DOCKET
09-AFC-8

Re: Genesis Solar Energy Project; 09-AFC-8

**TESTIMONY OF SCOTT CASHEN
ON BEHALF OF THE CALIFORNIA UNIONS FOR RELIABLE ENERGY
ON BIOLOGICAL RESOURCES FOR
THE GENESIS SOLAR ENERGY PROJECT**

ATTACHMENT 2

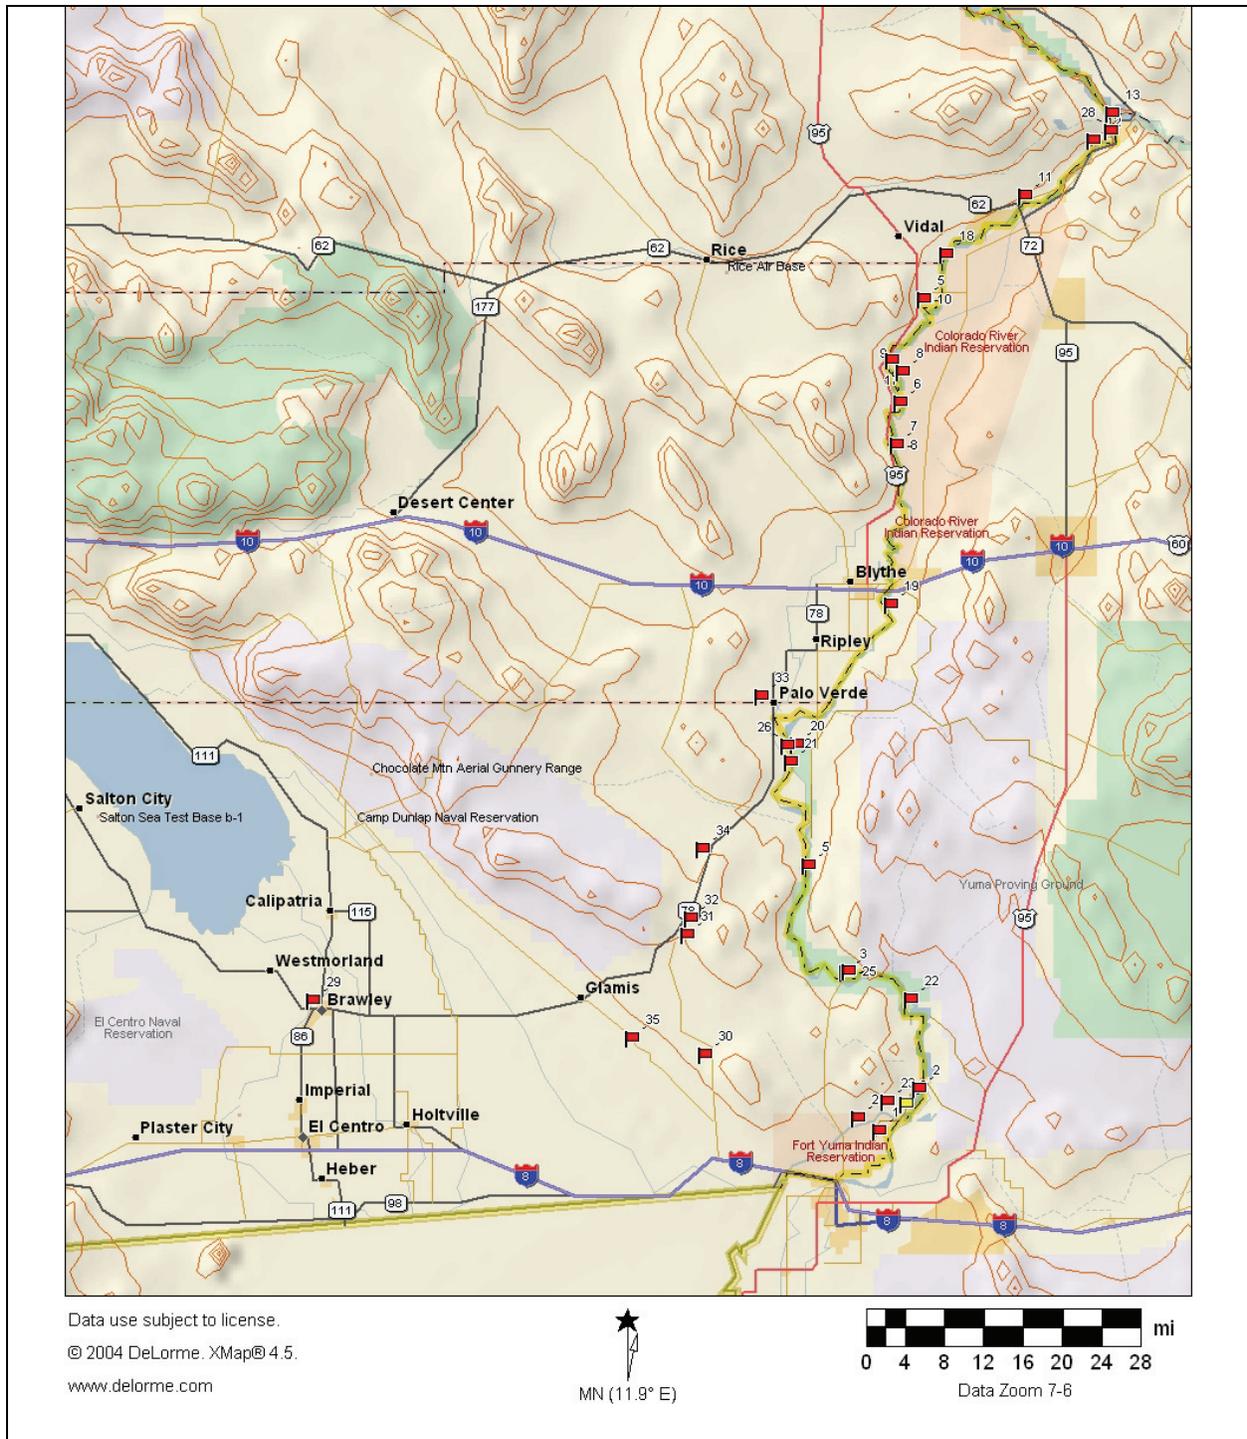
The RSA states Gila woodpeckers formerly occurred in desert washes up to one mile from the Colorado River, and that they are currently limited to areas along the Colorado River.⁵ Staff has not cited the source of this information. However, based on the verbiage, Staff’s information appears to have been derived from either the 1987 petition to list the species,⁶ or the 2002 NECO Plan.⁷ While technically correct at the time the documents were published, the information presented in these sources is now outdated. Since the documents were published, researchers have discovered populations of Gila woodpeckers at several locations west of the Colorado River. These locations are documented in the California Natural Diversity Database (CNDDDB) (illustrated in Attachment 2),⁸ and in the Desert Bird Conservation Plan published by California Partners in Flight and Point Reyes Bird Observatory (illustrated in Attachment 3).⁹

The RSA concludes that the Project area does not contain suitable habitat for the Gila woodpecker.¹⁰ However, the RSA does not provide a citation or any information to justify this conclusion. Several studies and surveys have documented Gila woodpeckers breeding in dry desert wash woodlands such as those that occur in the Project area. Grinnell and Miller (1944) reported Gila woodpecker habitat as:
